ADDENDUM NO.: 02

PROJECT: A New Branch Office
Johnson City Branch
622 N. Nugent Avenue
Johnson City, Texas 78636

Responses to Questions form Bidders:

F ROOF BEAM AND JOIST TO COLUMN
1/2" = 1'-0"

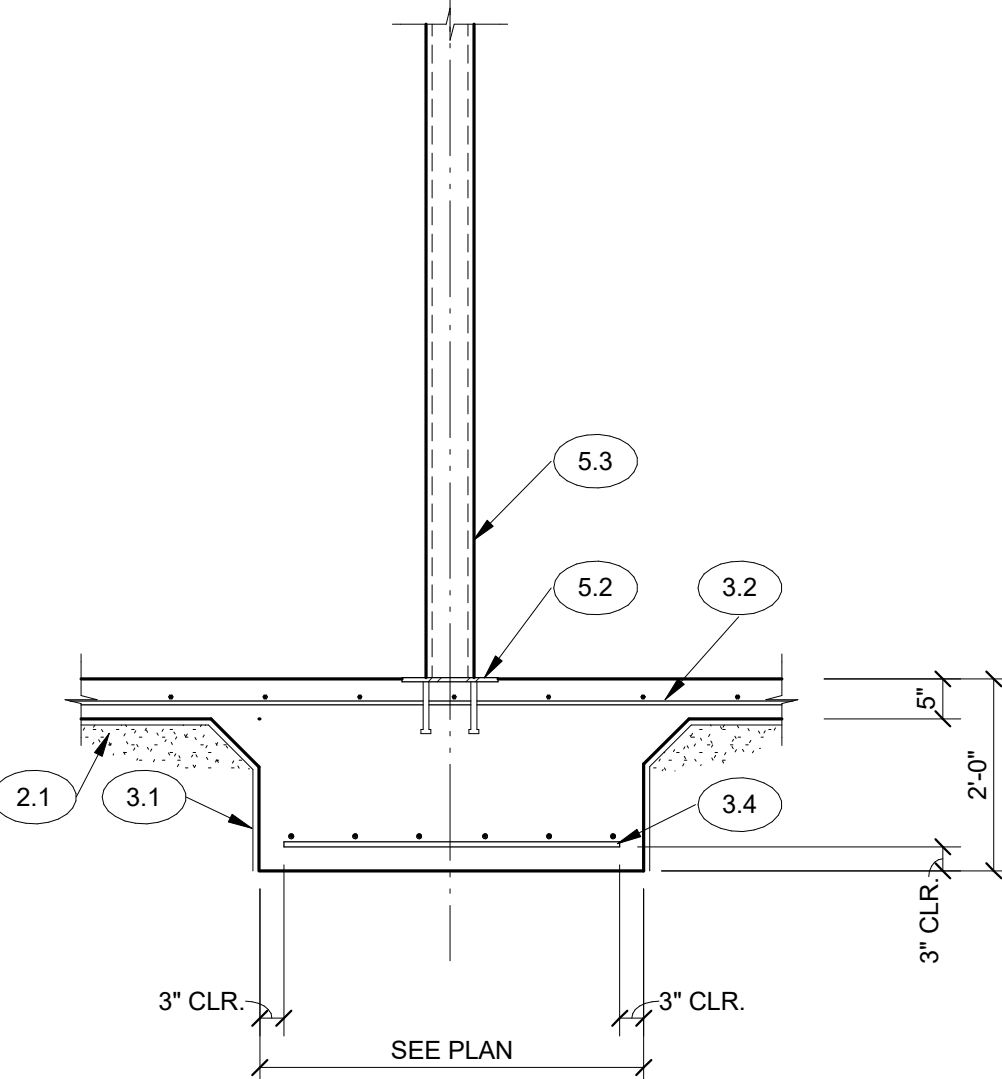
Question 08 - Can you look at drawing S-2.2, detail F

It is calling out for item 5.77, which under keynotes item 5.77 states the following: HSS___x___x___. What size is the HSS, please advise.

Reply: The steel tube size that should be noted in Keynote 5.77 is an HSS6x2x1/4 rectangle tube laid flat. This beam is to catch the lower roof joists since they come in slightly above the lower beam carrying the mechanical platform

See attached sheet S-2.2
